Notice of Allowability

10/525,074

KIM ET AL.

FIG. 1

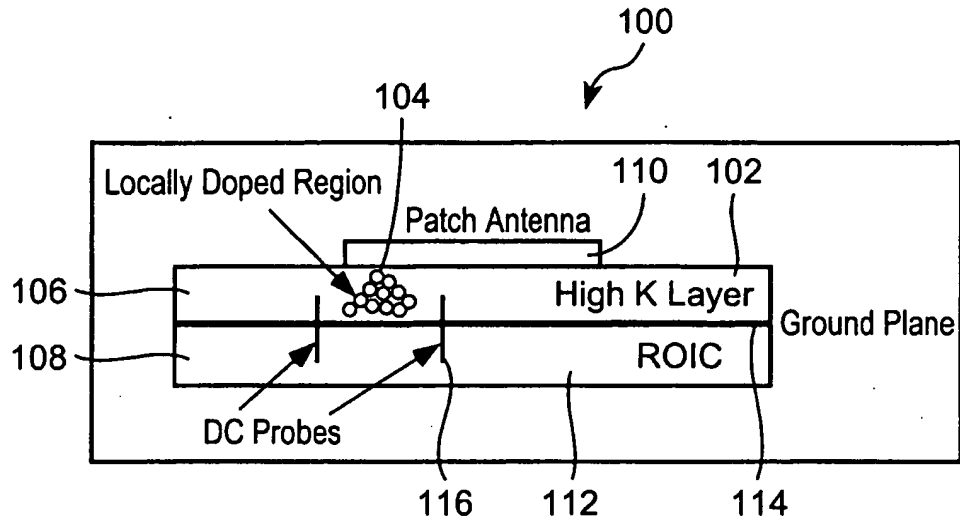
In the drawing: The label of "FIG. 1" has been changed to "THE FIGURE" (See attachment).

THE FIGURE
